EIA for new NPP Dukovany

Statement of the Joint Project – Nuclear Risk & Public Control

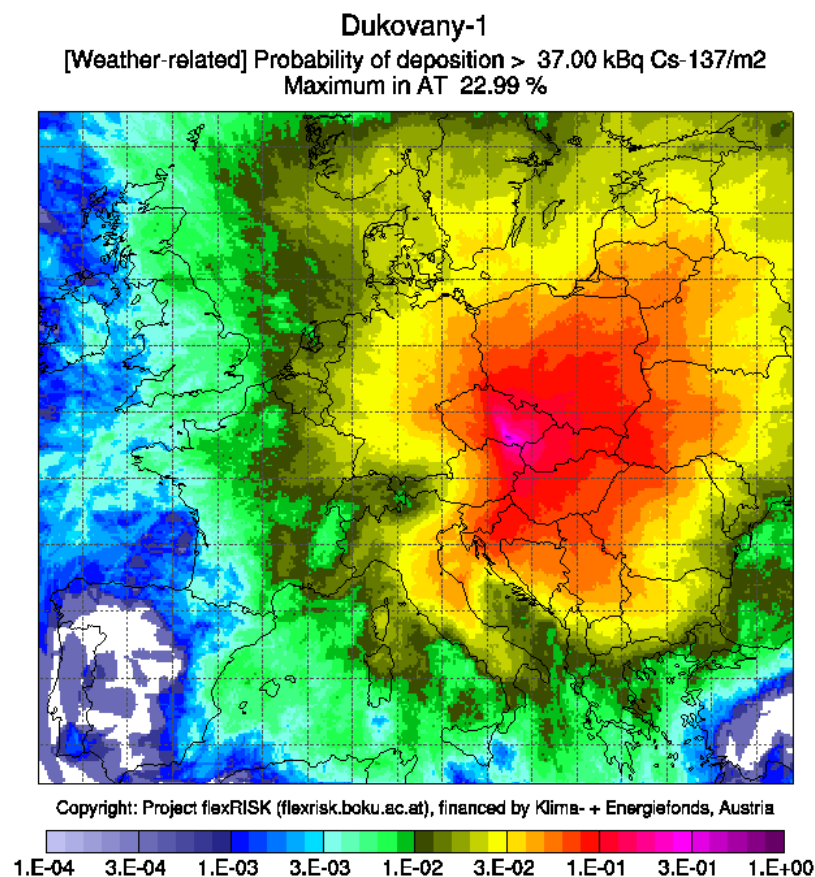
The above discussed calculations of a severe accident are not showing the worst scenario – which would be a release of a large part of the inventory. Such a large release was modelled in the project flexRISK for a release of 76,05 PetaBecquerel Cs-137 (which is 2,500-fold the source term of 30 TBq that was used in the EIA). Even if such a big release has a very low possibility it cannot be excluded totally from assessment!

flexRISK⁴ shows which regions in Europe would be probably affected based on realistic European weather conditions. Even though the following example was calculated for Dukovany-1, it provides a good impression of what to expect in a worst case scenario.

The figure shows the weather-related probability to be contaminated with more than 37 kBq Cs-137 in case of a severe accident at the Dukovany site. The scale goes from 100 % probability (purple end 1.E+00) down to 0.01% (1.E-04). An accident with a very large release has impacts on all over Europe.
